INITIAL FIRE SAFETY INSPECTION REPORT

KORMOP CO.LTD.

Date: 24-Feb-2025

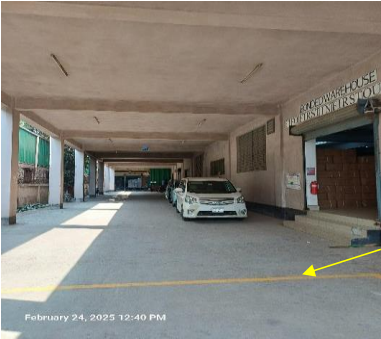
2	Fire-Rated Construction	Floor to floor penetrations were found due to plumbing pipes and BBT riser's in all floors level of Factory Building-2 and plumbing pipe at transformer room on the ground floor of Factory Building-1. Location: Factory Building-2 & Factory Building-1.	Provide a minimum 2-hr fire rated shaft to separate the utility risers from each floor level or seal all penetrations and openings in floors/ceiling assemblies by 3-hr fire rated listed/certified materials. The installation of such fire rated materials shall be following certified design.	Within 3 months

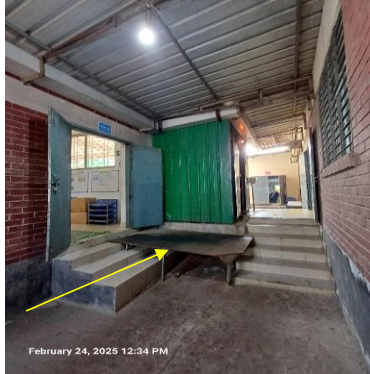
5	Means of egress	Both exit Stair discharge the occupant inside the building on the ground floor. Location: Factory Building-2.	1. Modify stair to discharge directly outside. Or 2. Provide 1-hr fire-rated exit passageway leading directly outside (vestibules to separate any storage areas). Note: A maximum of 50 percent of the number and capacity of the exit enclosures can discharge through areas on the level of exit discharge where all the conditions described in RSC building standard 6.17.3 are met.	Within 3 months
---	-----------------	--	--	-----------------

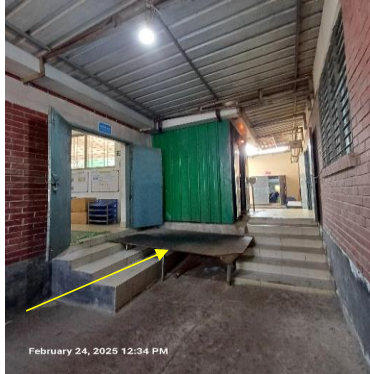
6	Fire Rated Construction	Flammable liquid (diesel storages of approximately 3000 litre) was found without any fire separation distance and exterior wall rating, as per BNBC 2006 requirements besides stair-1 & lift on the ground floor. Location: Factory Building-2.	The diesel tank shall be separated or exterior walls shall have a fire resistance and opening protection in accordance with BNBC 2006 Part 3 Table 3.2.2. Additionally a license must be obtained in accordance with the Petroleum Act for all storage of Class II petroleum greater than 1000 L (264 gal) individually and 2000 L (528 gal) aggregate and storing criteria shall be followed as per the license provided by the Department of Explosives Bangladesh.	Within 3 months

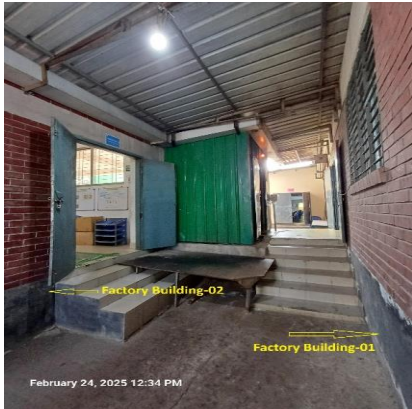
12	Means of egress	Both the width of Stair-1 & Stair-2 was measured 47 inches which is not as per standard. Location: Factory Building-2.	In new and interim construction and constructed stairs post 24 November 2013, stairs shall have a minimum width of 1.5 m (60 in.) for all industrial occupancies and 2.0 m (79 in.) for all assembly occupancies. For assembly use areas provided for prayer halls, dining halls and like areas that are for integral use by the factory workers, the minimum width for the primary occupancy use of the building shall be permitted to be used.	Within 3 months

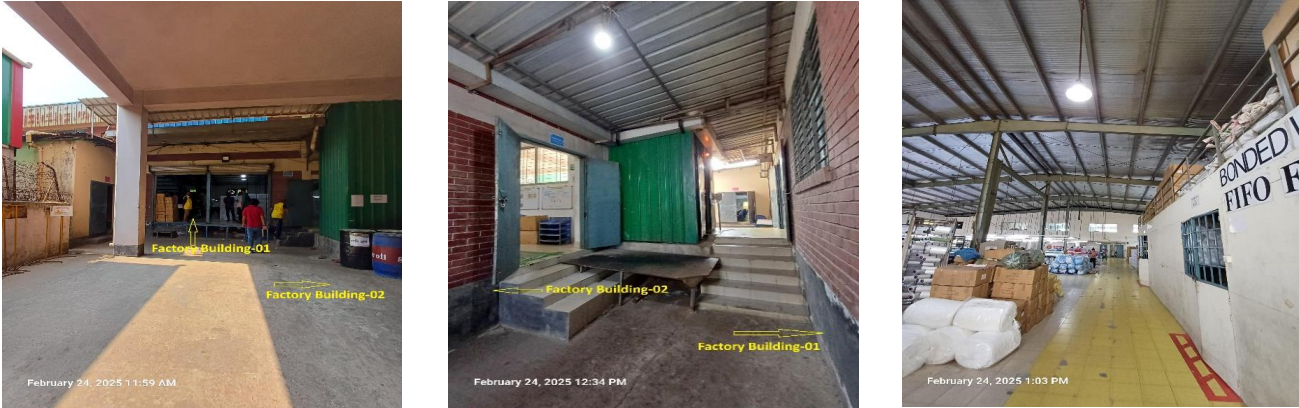
14	Means of egress	Handrails are provided at one side of both exit stair and height of the handrail was found 32 inches. Also, no handrail was provided at stair stair-1 at discharge. Location: Factory Building-2.	Provide handrails on both side of the stairs which have a minimum height of 865 mm (34 in.) and a maximum height of 965 mm (38 in.) as measured from the leading edge of the tread. Guards are required to be according to RSC Technical Guidelines 6.12.2 (a sphere of 200 mm (8 in.) in diameter cannot pass through any opening up to a height of 865 mm (34 in.).	Within 1 month

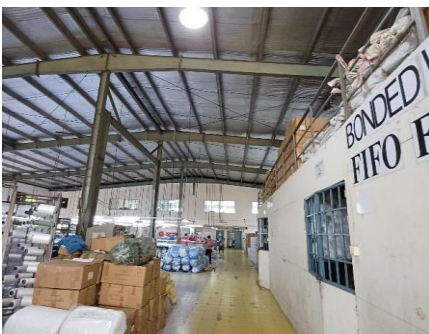
27	Fire Rated Construction	Compressor room is not properly separated by fire rated construction. Location: Factory Building-1.	Compressor or other heat producing equipment shall be separated from other occupancies by a minimum 1-hr fire rated construction (wall, floor, slab etc). Seal all penetrations and openings (door, window etc.) should be protected by 0.75-hr (45 min) fire rated materials to maintain the fire separation if required. Or Relocate it to exterior of the building and maintain a minimum 3m (10 ft.) spatial separation distance from the building.	Within 2 months
----	-------------------------	--	--	-----------------

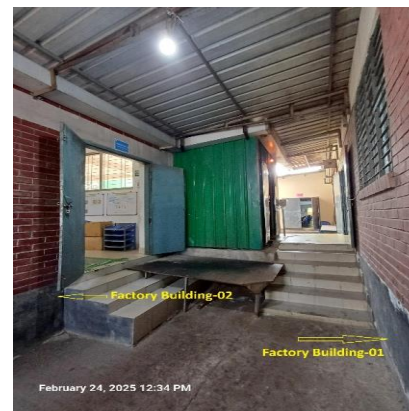
29	Means of egress	Handrails were not installed at the stairs of both the south and west exits at the discharge area. Location: Factory Building-1.	Provide handrails on both side of the stairs which have a minimum height of 865 mm (34 in.) and a maximum height of 965 mm (38 in.) as measured from the leading edge of the tread.	Within 1 month
